MARCH 13, 2019

NEW HAVEN RAIL YARD FACILITY IMPROVEMENT

STATE PROJECT NO. 0300-0138

ADDENDUM NO. 2

Figure 1 - Existing Floor Plan

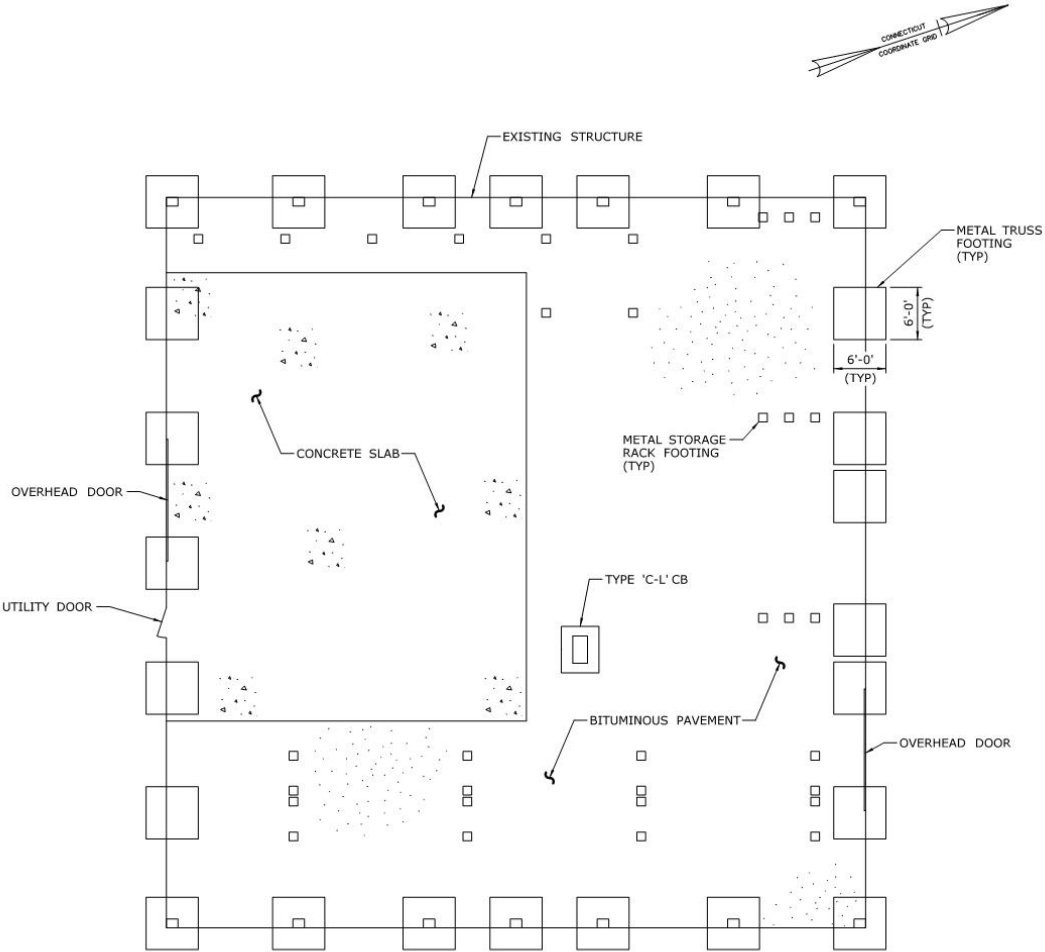
Except as otherwise specified, the Contractor shall break up, demolish and remove existing Building 10A from site for disposal/recycling to include:

1. The entire 83' x 80' truss house type structure, fabric covering, overhead doors, and utility door.
2. All interior electric panelboards, overhead heaters, lights, and associated conduits.
3. All interior surface debris, and concrete pads.
4. All interior bituminous type pavement.
5. All footings and foundations to a minimum depth of 48 inches below existing grade.
6. All interior drainage structures and pipes to limit of building footprint, including plugging of all pipes.

For additional information, see Figure 1 - Existing Floor Plan and Figures 2 thru 6 – Interior Photographs circa August 2017.
